# TECHNICAL BULLETIN FC-01

DATE: NOVEMBER 7, 2005 (Revised 1/07)  
 MODEL YEAR: 2005 AND AFTER  
 ENGINE MODEL: J05D-TA and J08E-TE  
 CHASSIS MODEL: UD1800CS, UD1800HD ~ UD3300  
 BULLETIN NUMBER: FC-01  
 FILE IN THE FUEL SECTION OF THE TECHNICAL BULLETIN BINDER

## ENGINE THROTTLE CONTROL SWITCH MOUNTING

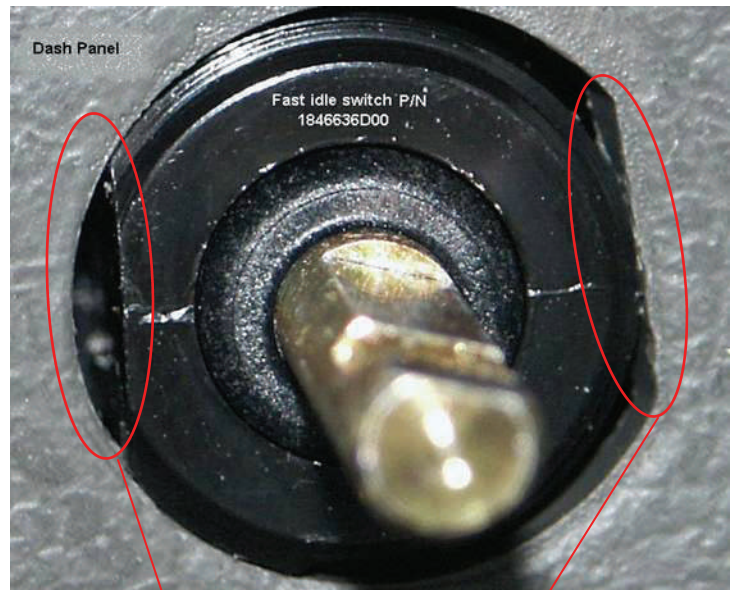
The engine throttle control switch (fast idle), may rotate in the dash mounting hole beyond the notched index.

Field reports have found that the engine throttle control switch can rotate beyond the notched index if excessive force is used, resulting in twisted wiring and connections.

To prevent the switch from rotating, install a serrated (star) washer between the switch's back up washer and the instrument panel.
